ROADWAY PLANS WYOMING ESTATES SUBDIVISION EL PASO COUNTY, CO

PCD PROJECT NO. MS196

ROADWAY COVER

ROADWAY PLAN,
PROFILE, DETAIL AND
SECTION

SITE MAP

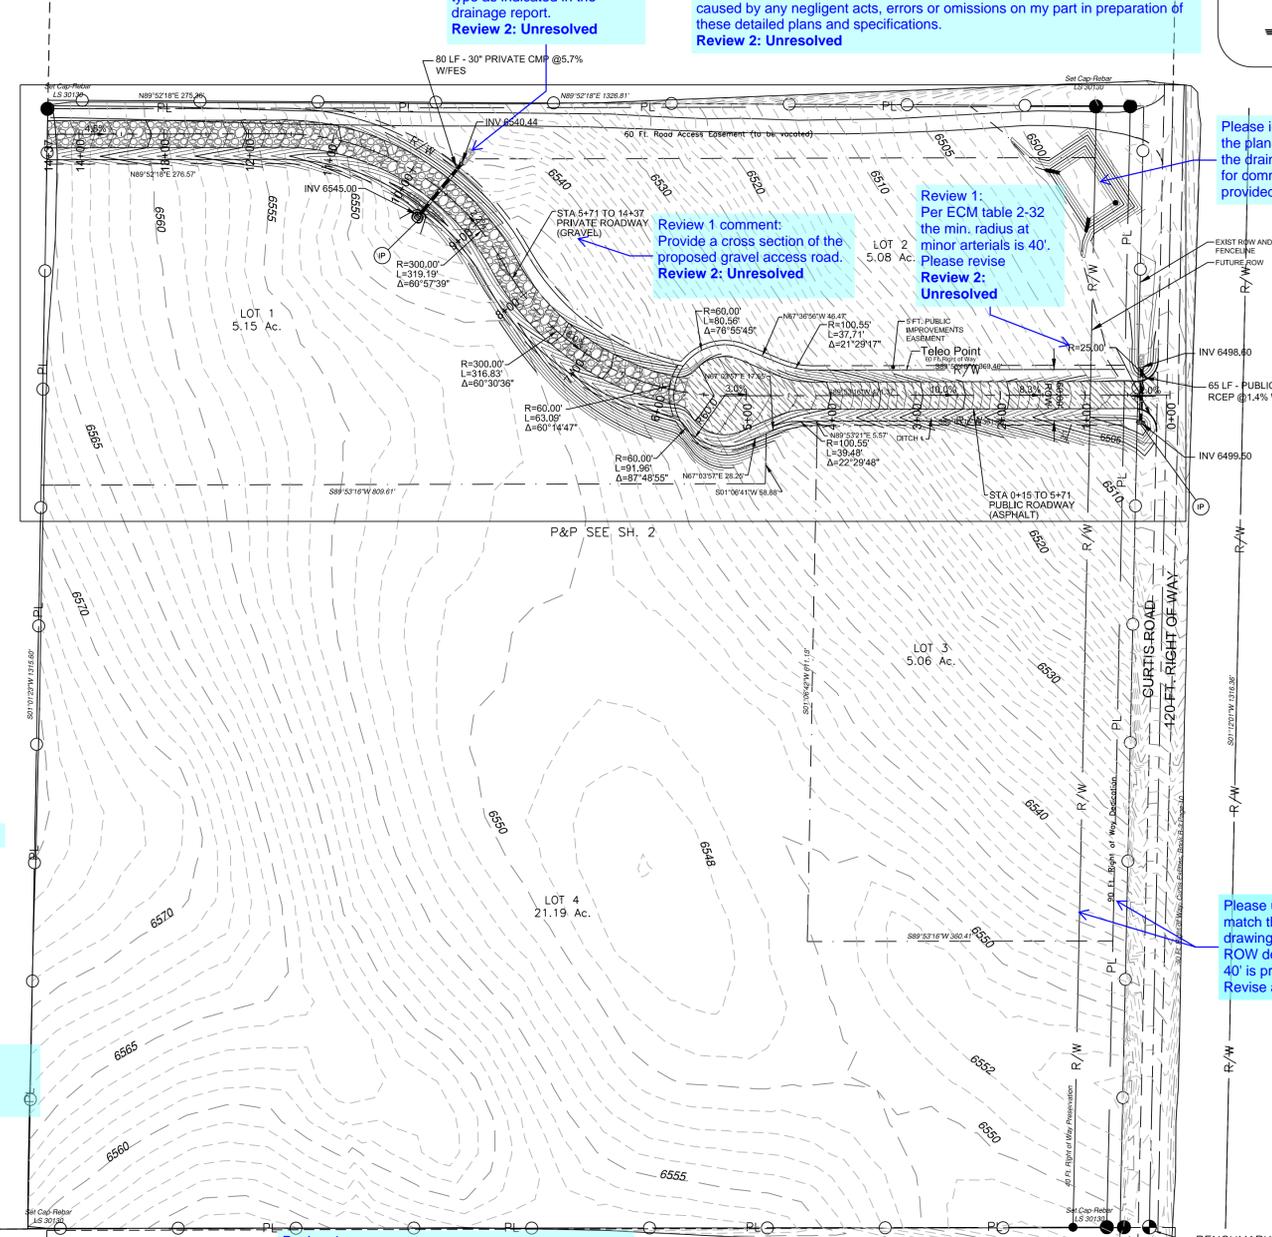
Revise to Planning and Community Development Department

SECTION A
TYP RURAL LOCAL CROSS SECTION - 60' R.O.W.
NOT TO SCALE

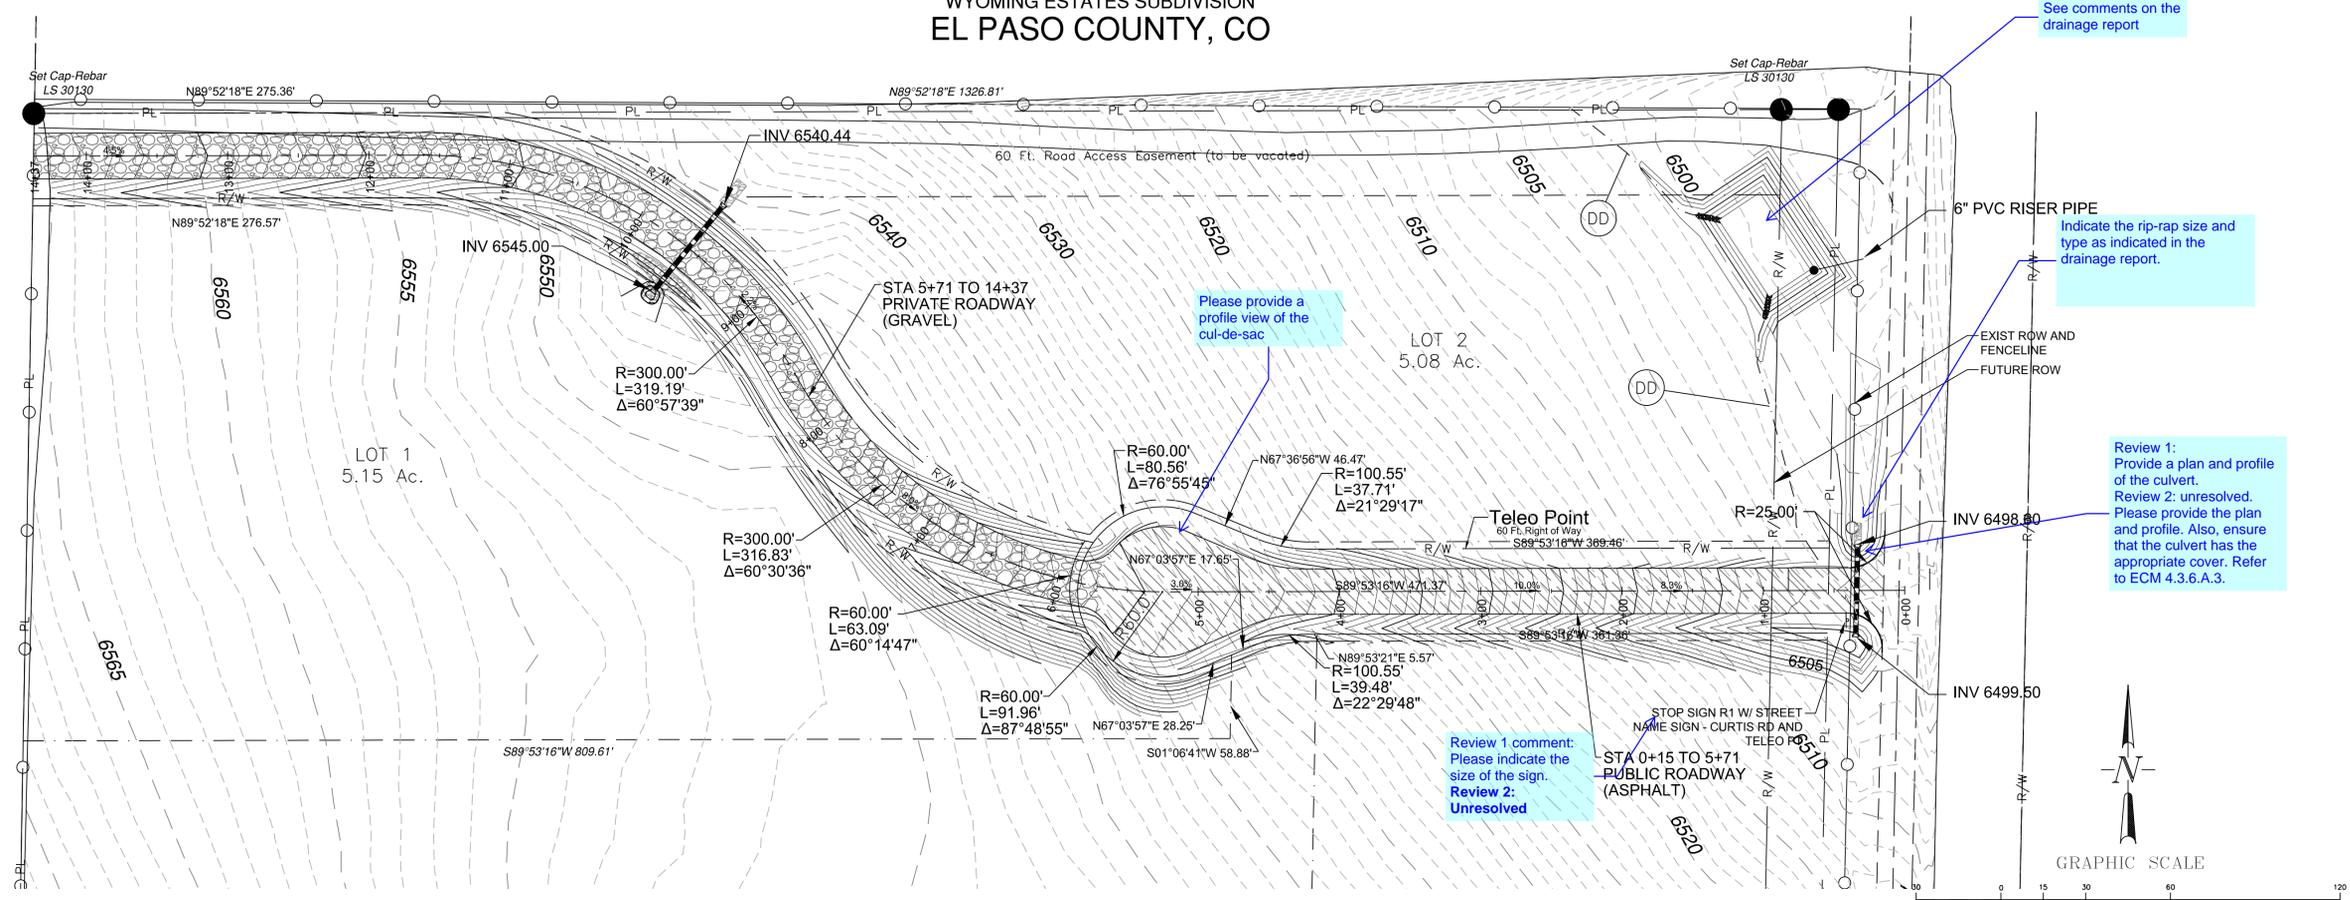
Review 1 comment: Provide a cross section of the proposed gravel access road.
Review 2: Unresolved

Please show the slope per the standard County detail as well as the point of slope selection (hinge point)

Please label the 5' public improvements easement.

PROFILE OF TELEO PT
SCALE: HOR 1" = 60' - 0", VER 1" = 10' - 0"

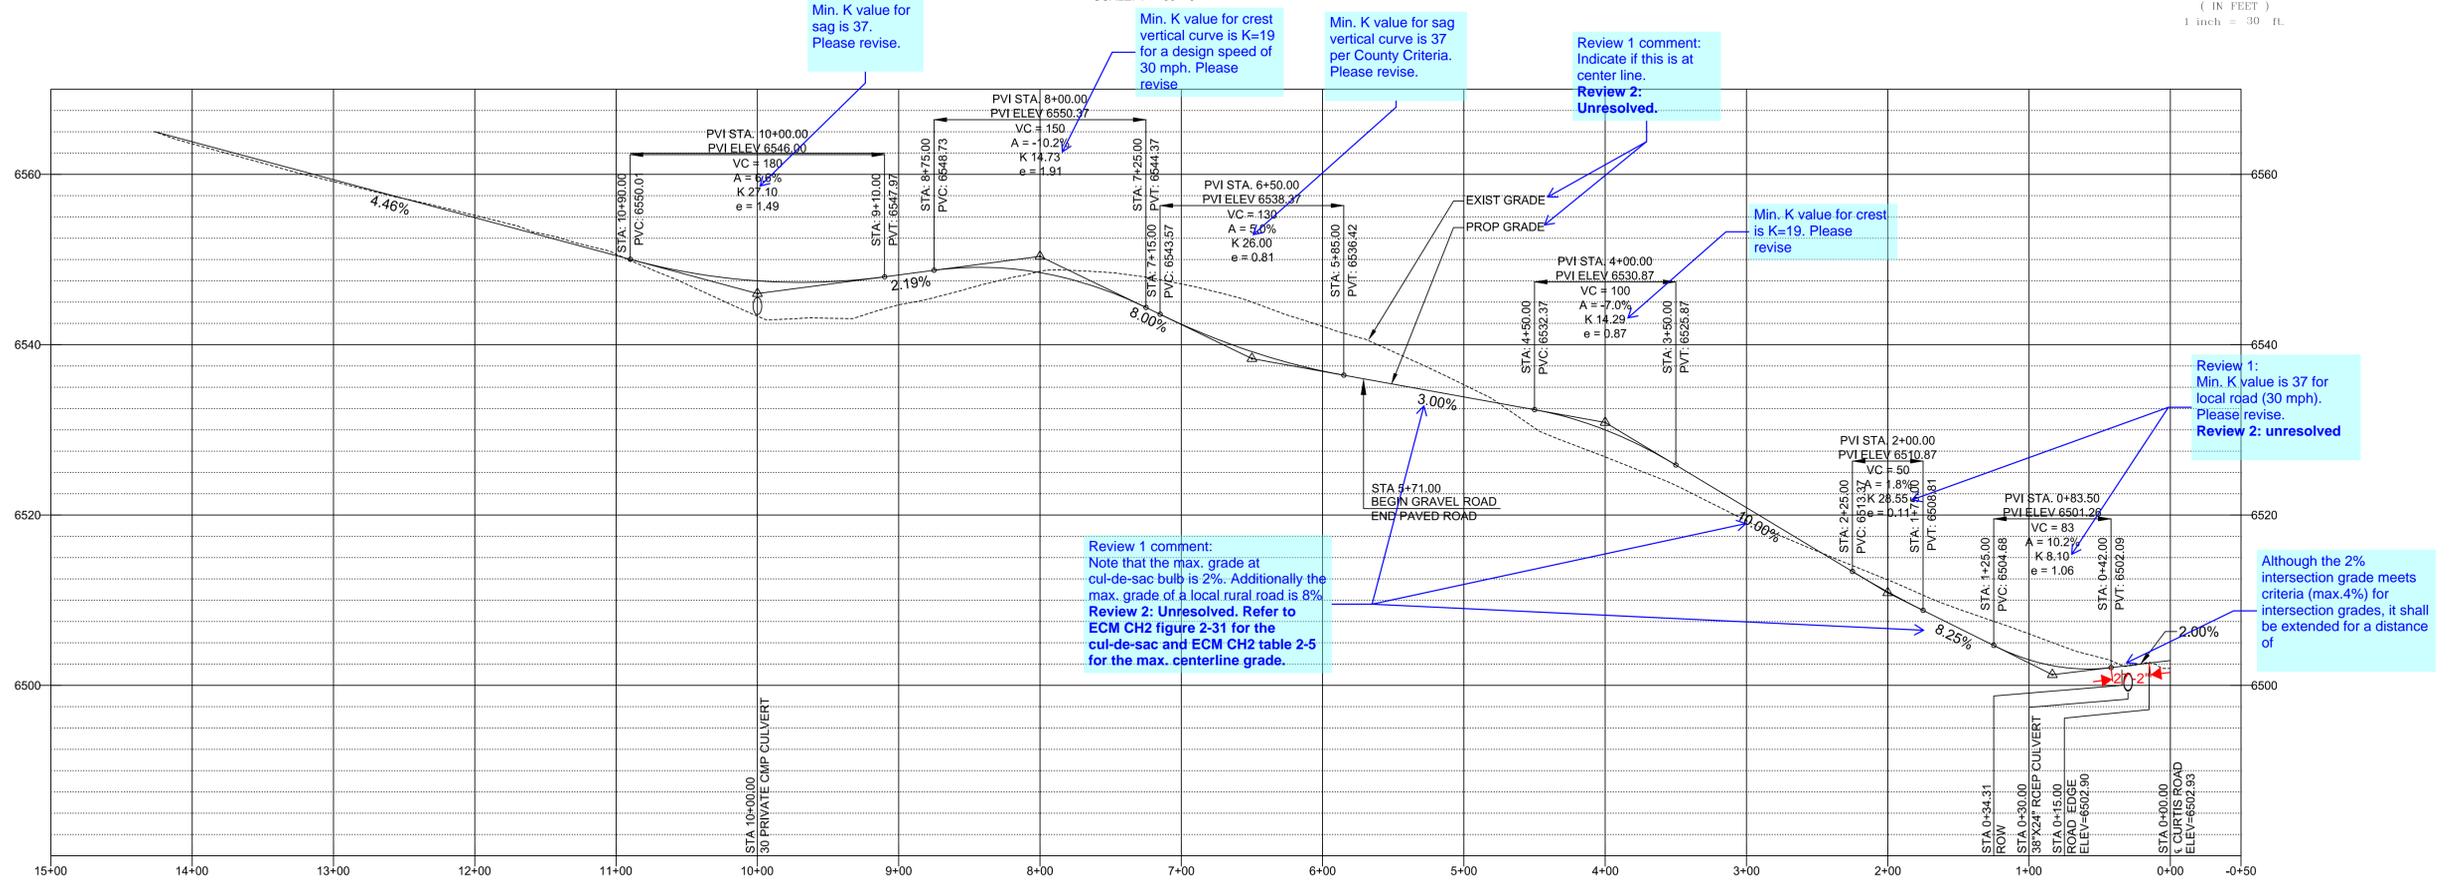
Review 1 comment: Indicate the rip-rap size and type as indicated in the drainage report.
Review 2: Unresolved

Review 1: Per ECM table 2-32 the min. radius at minor arterials is 40'. Please revise.
Review 2: Unresolved
